TN_VAG_04/ 2021

Battery fuse

2020 TCR TECHNICAL REGULATIONS

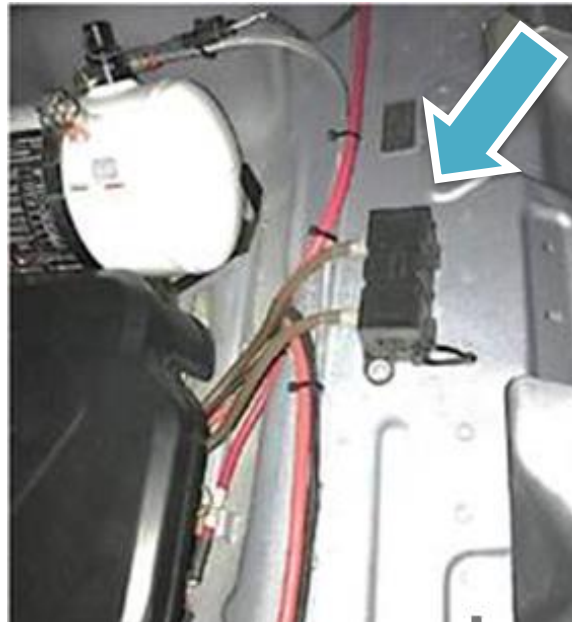
A battery fuse 300A must be added to the ground between battery ground and chassis ground

- Exchange the battery ground cable to the fuse kit 5F6915423
- Battery fixation position as shown in the pictures below.
